757

Service Bulletin

Number: 757-53A0103

SUBJECT: FUSELAGE - Section 43 and Section 46 - Structure - Inspection and Modification of
Open Holes on Frame Webs Between Stringers S-20 and S-25

**FIGURE 3: MODIFICATION OF FRAME WEB BETWEEN STRINGERS S-20 AND S-25 FROM STA 440 TO STA 820 AND FROM STA 1300 TO STA 1701
(SHEET 1 OF 4)**

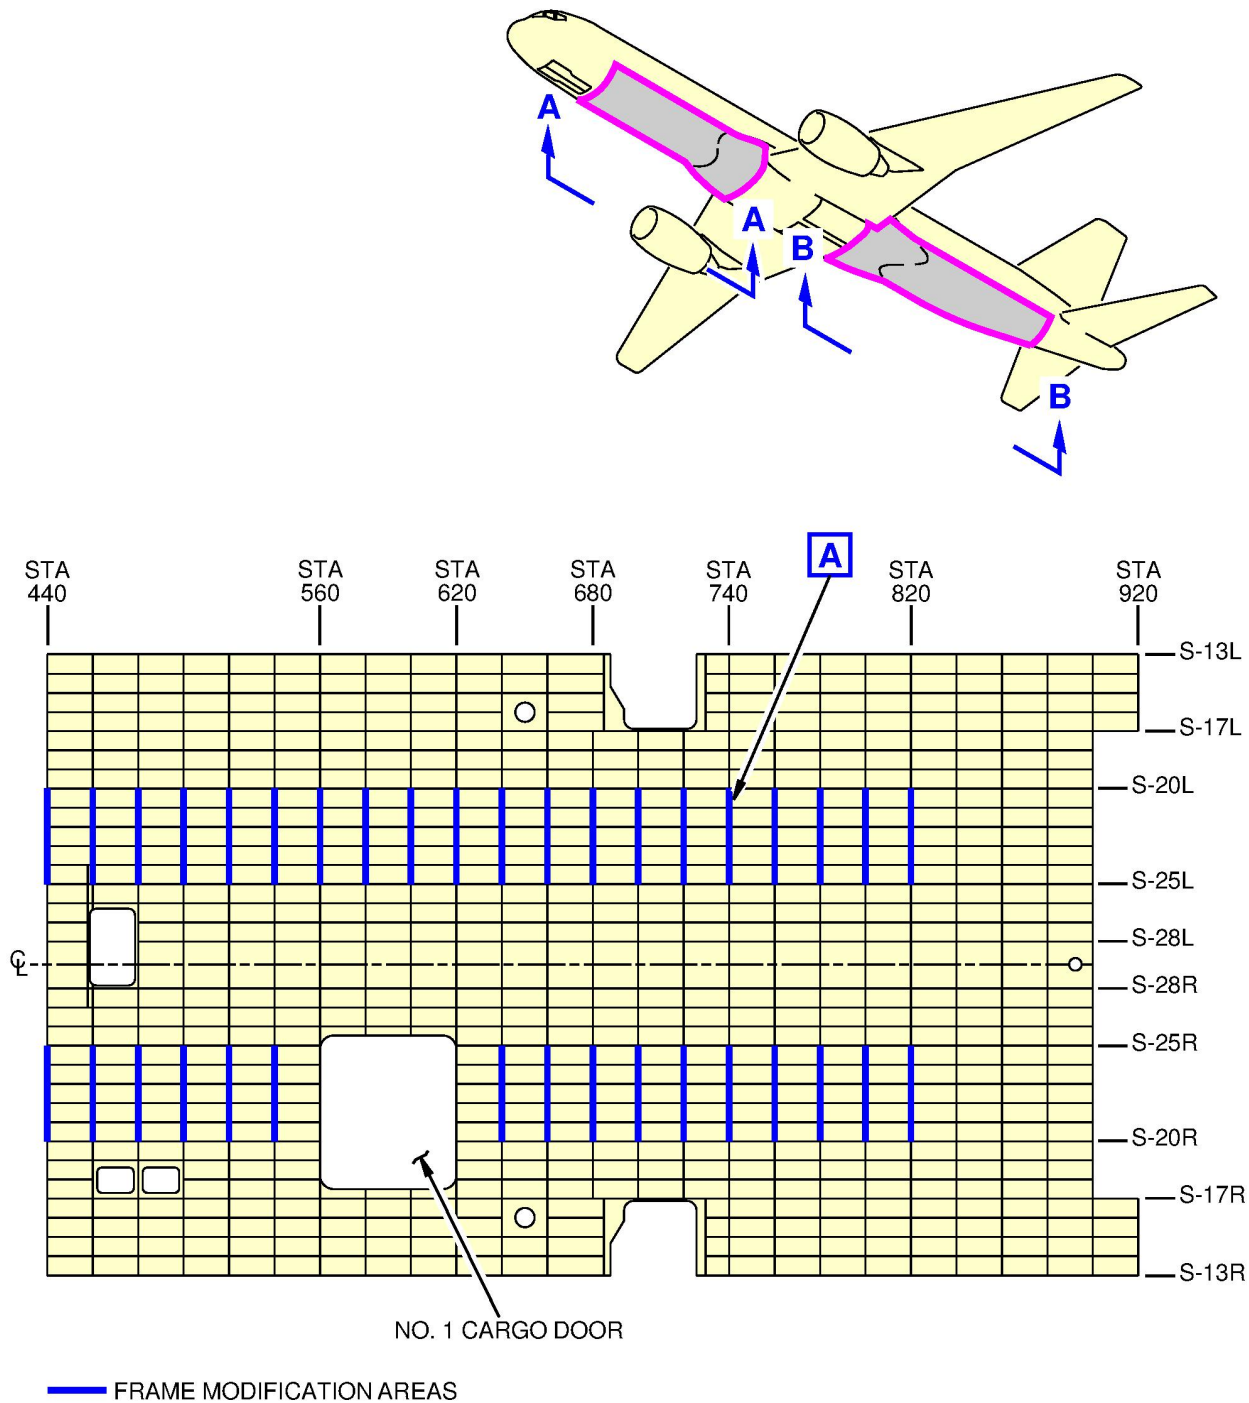
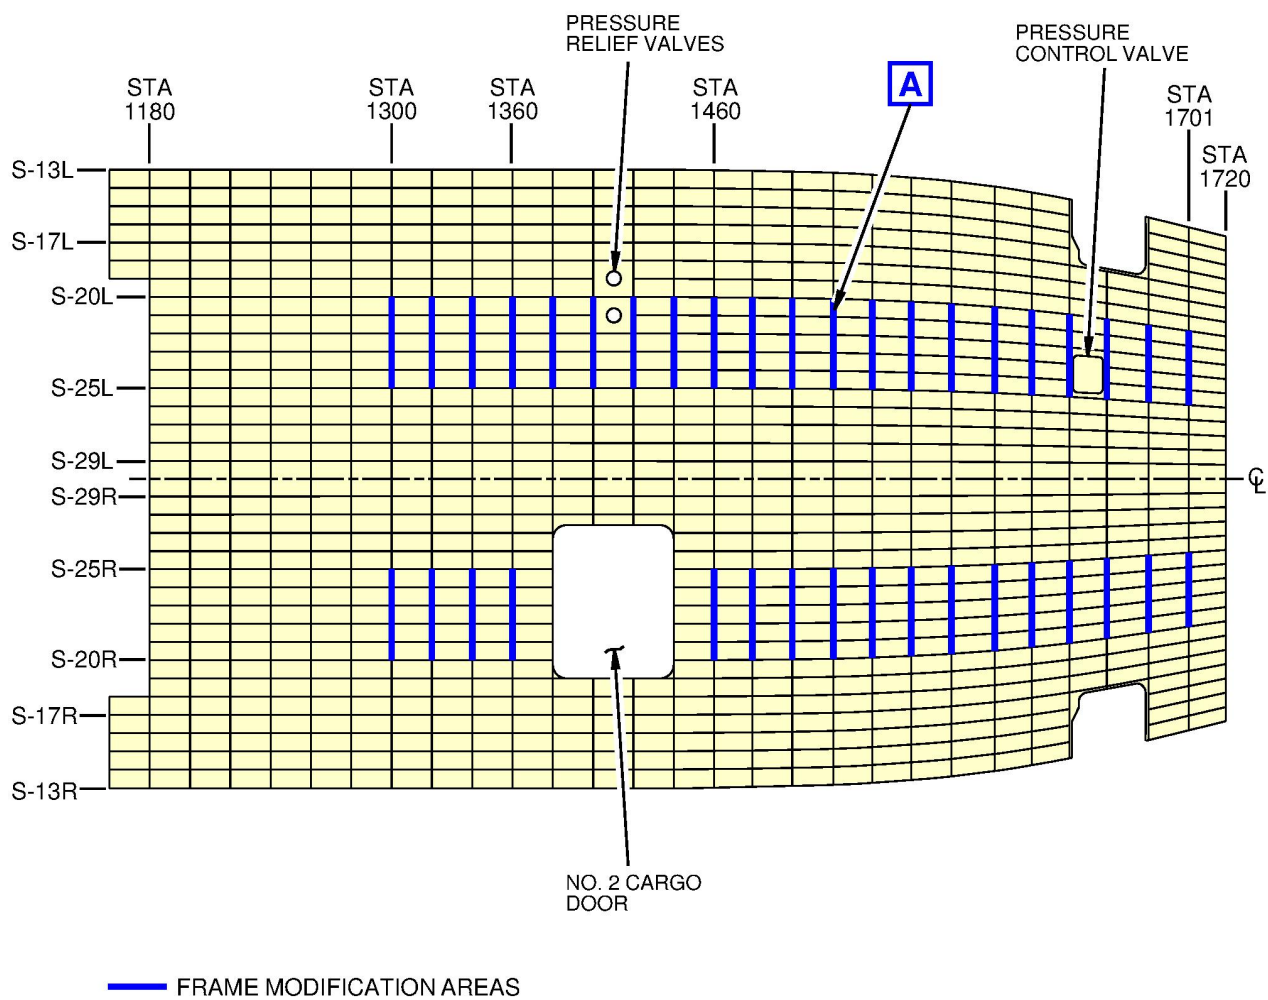
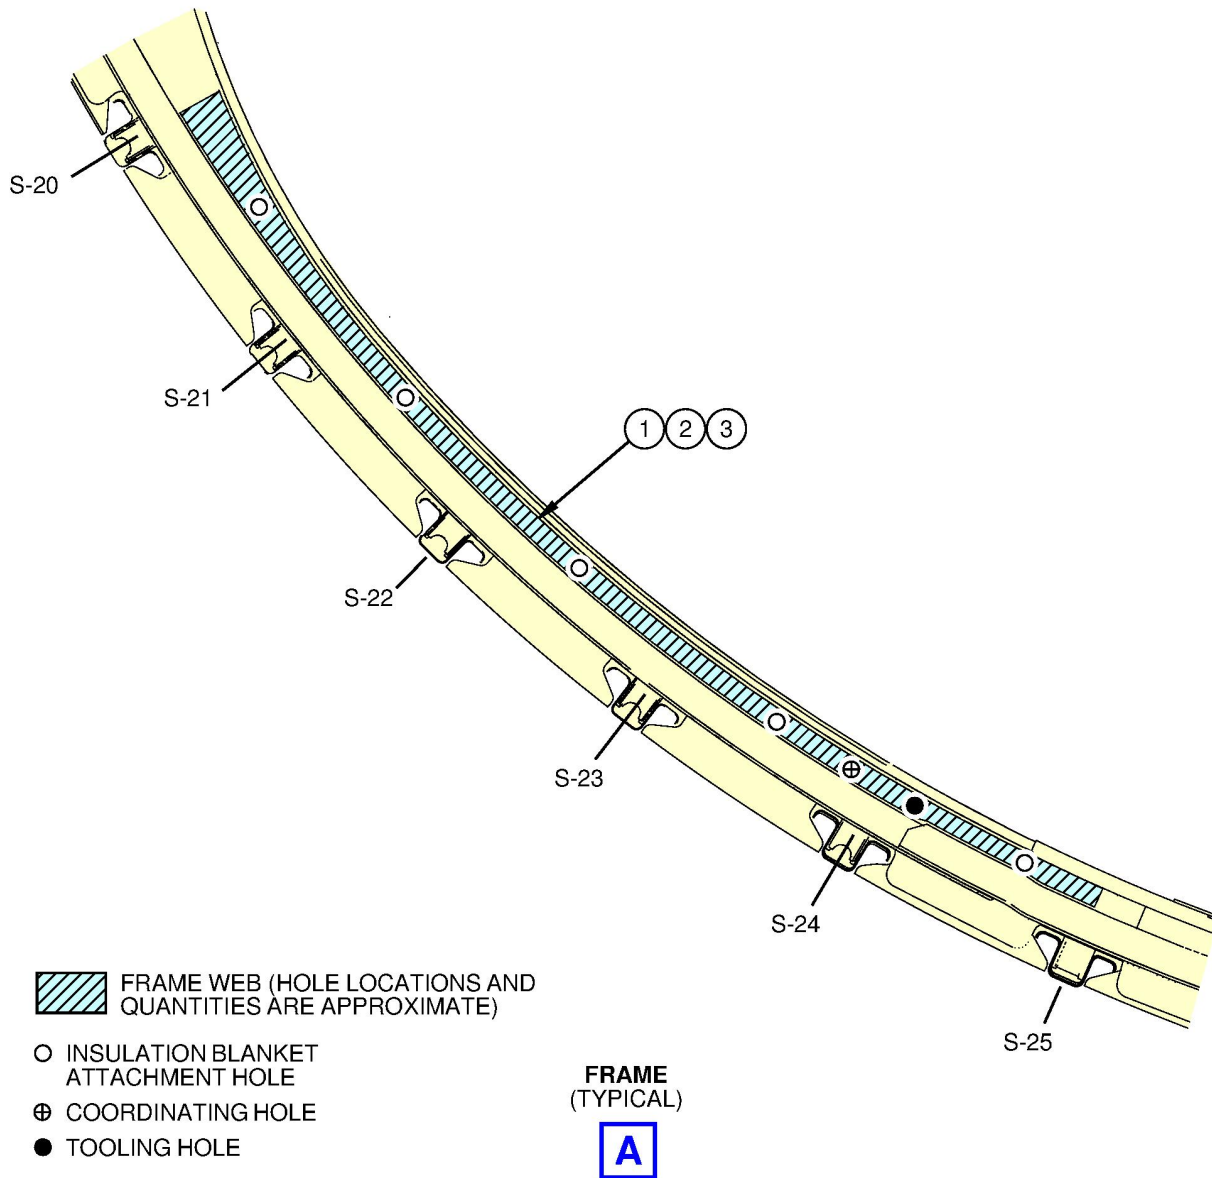
If no crack is found at an open hole modify all open hole locations in accordance with FIGURE 3.

Step	Task	Name	Identification	Qty	More Data
1	Ream	OPEN HOLES	-	-	(a) (b)
2	Deburr	OPEN HOLES	-	-	(c)
3	Install (New)	RIVET	-	-	(d) (e)
(a) A typical coordinating hole has 0.278 - 0.291 inch diameter. A typical tooling hole has a 0.247 - 0.260 inch diameter. A typical insulation blanket attachment hole has a 0.154 - 0.166 inch diameter or 0.180 - 0.192 inch diameter.

(b) Increase the diameter of each open hole to the next nominal fastener size. Refer to 757-200 SRM 51-30-01 or 757-200PF SRM 51-30-01 as an accepted procedure.					
Hole diameter of 0.154 to 0.166 inch increases to 0.225 to 0.231 inch to install 7/32 diameter rivet.					
Hole diameter of 0.180 to 0.192 inch increases to 0.253 to 0.259 inch to install 8/32 diameter rivet.					
Hole diameter of 0.247 to 0.260 inch increases to 0.316 to 0.322 inch to install 10/32 diameter rivet.					
Hole diameter of 0.278 to 0.291 inch increases to 0.348 to 0.358 inch to install 11/32 diameter rivet.

(c) Remove all sharp edges.					
(d) Refer to Fastener Table for type of rivet.					
(e) Install rivets in all open hole locations. Refer to 757-200 SRM 51-40-02 or 757-200PF SRM 51-40-02 as an accepted procedure.

**FIGURE 4: MODIFICATION OF FRAME WEB BETWEEN STRINGERS S-20 AND S-25 FROM STA 440 TO STA 820 AND FROM STA 1300 TO STA 1701
(SHEET 1 OF 4)**

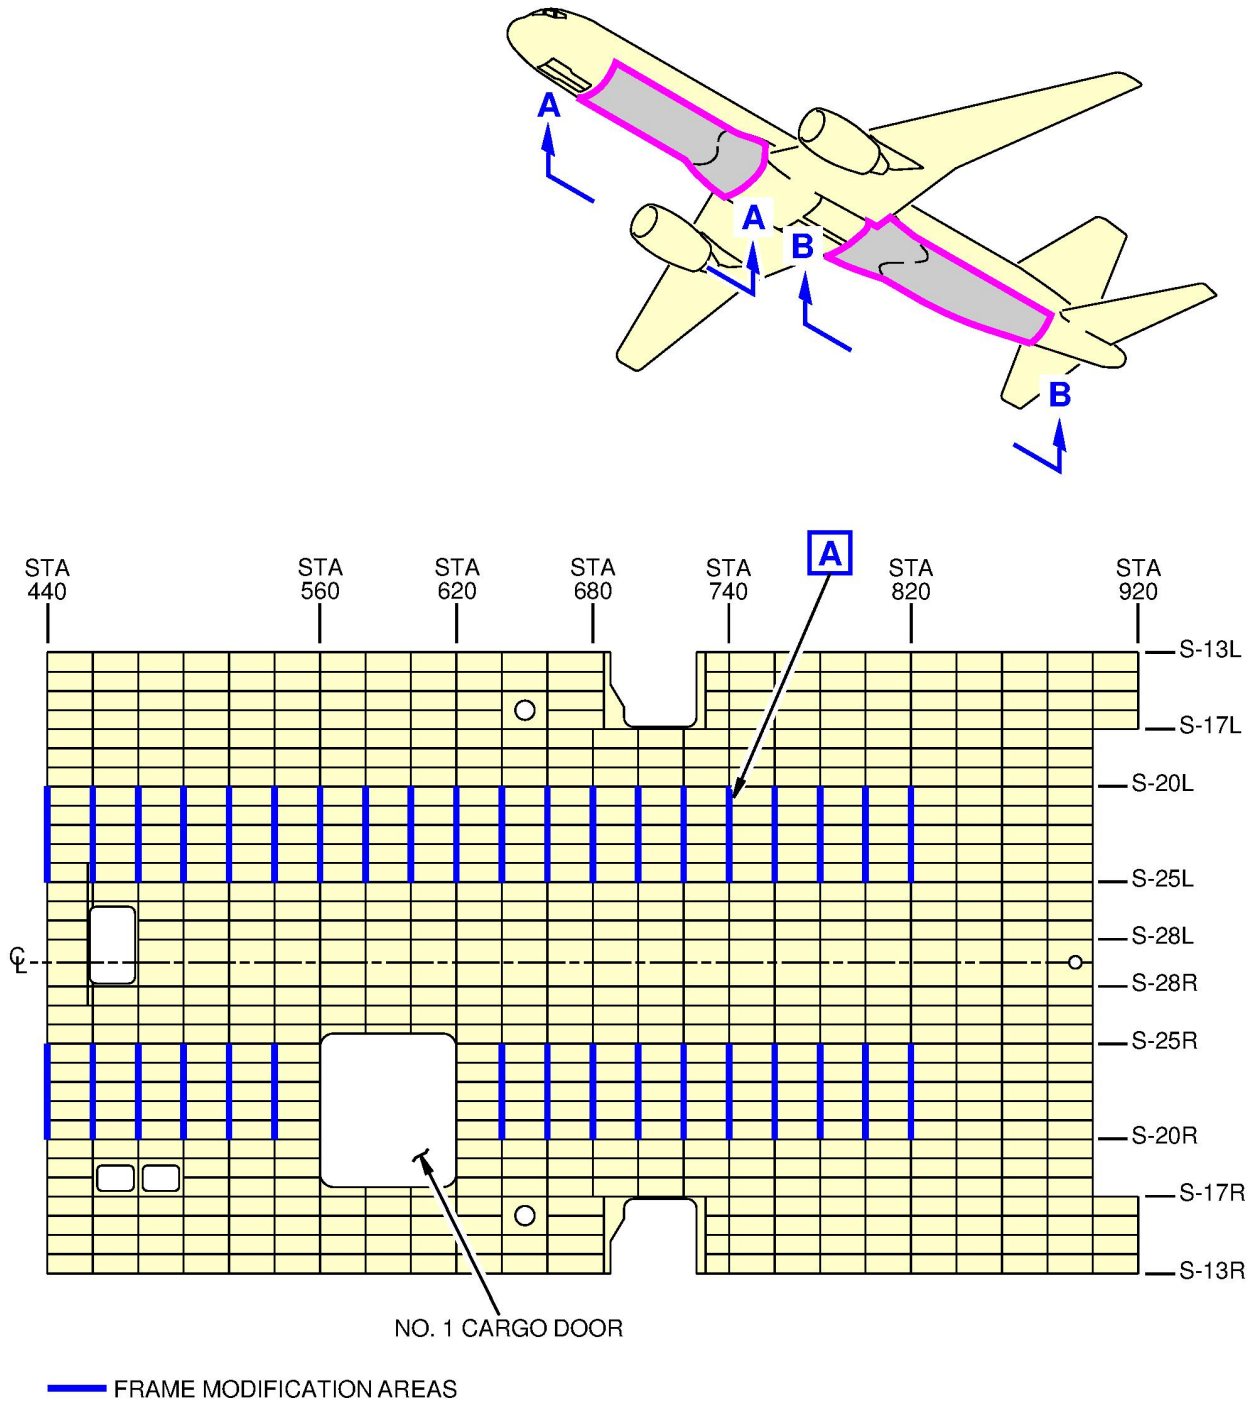
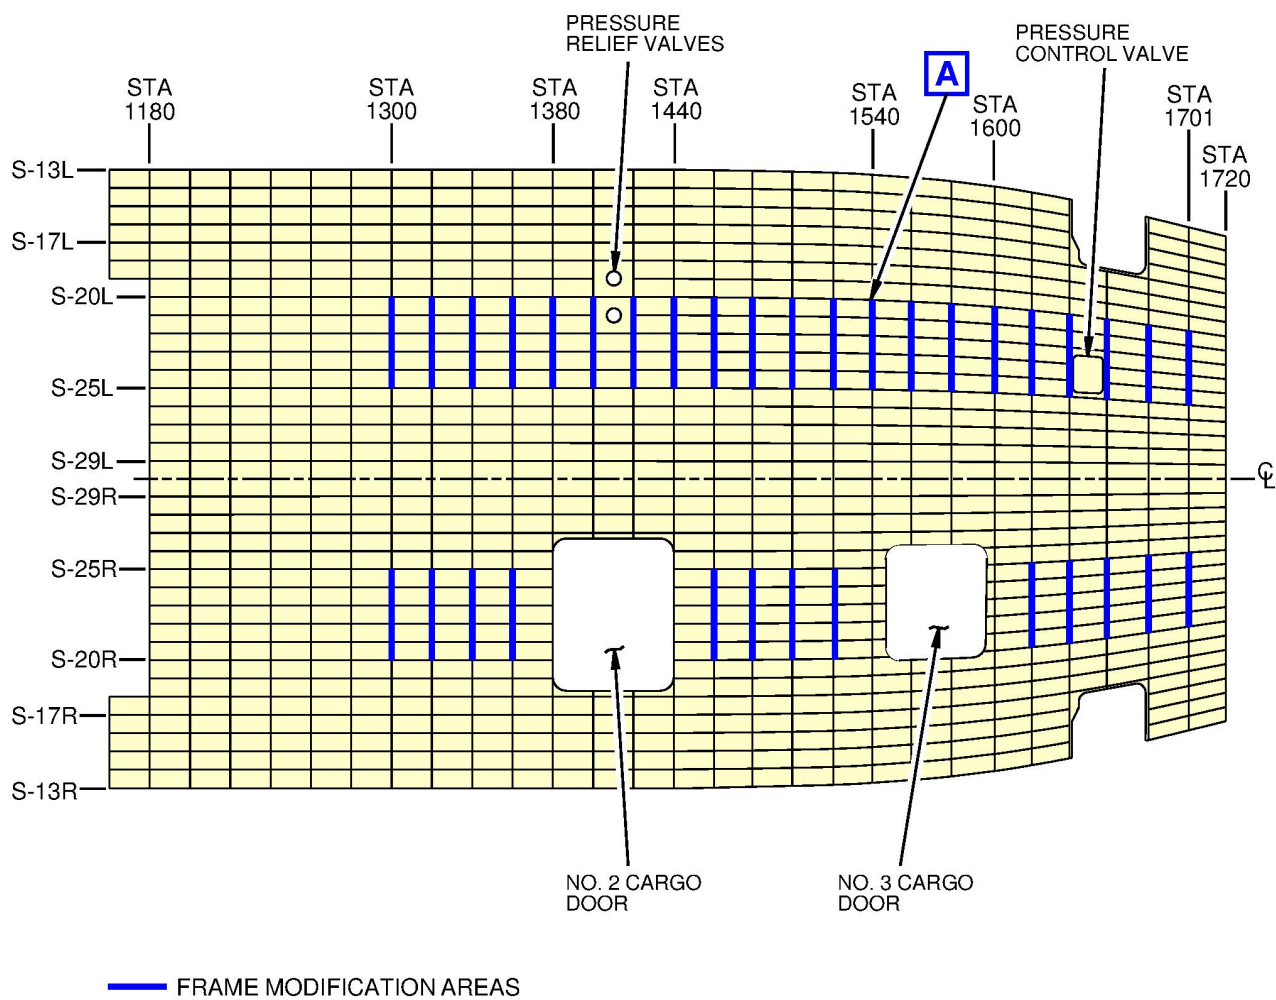
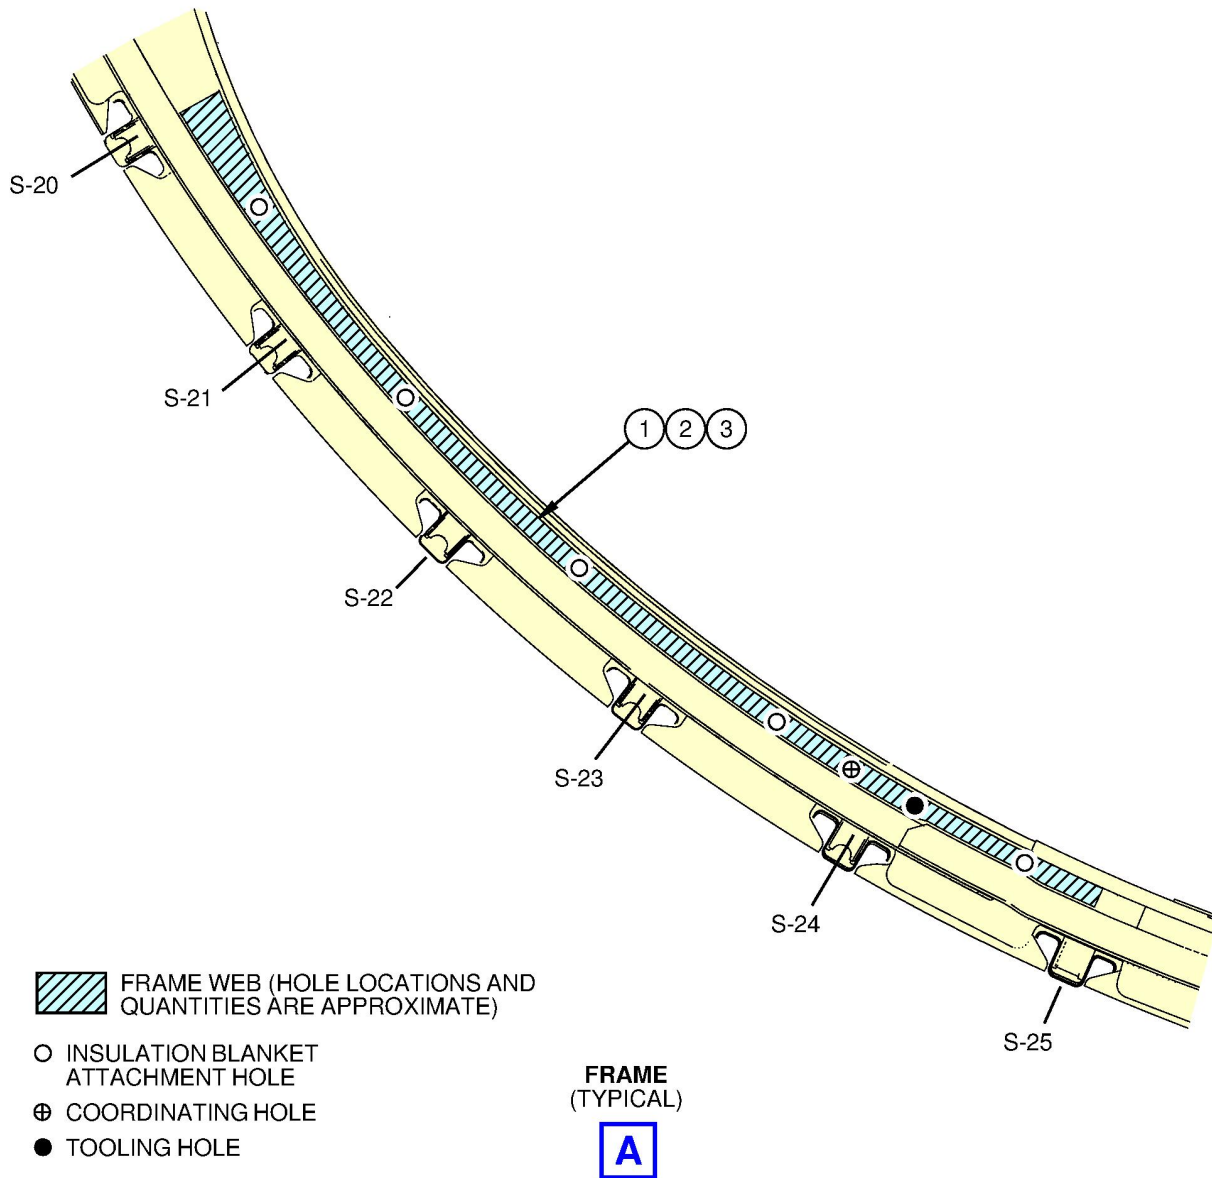
If no crack is found at an open hole modify all open hole locations in accordance with FIGURE 4.

(c) Remove all sharp edges.					
(d) Refer to Fastener Table for type of rivet.					
(e) Install rivets in all open hole locations. Refer to 757-200 SRM 51-40-02 or 757-200PF SRM 51-40-02 as an accepted procedure.
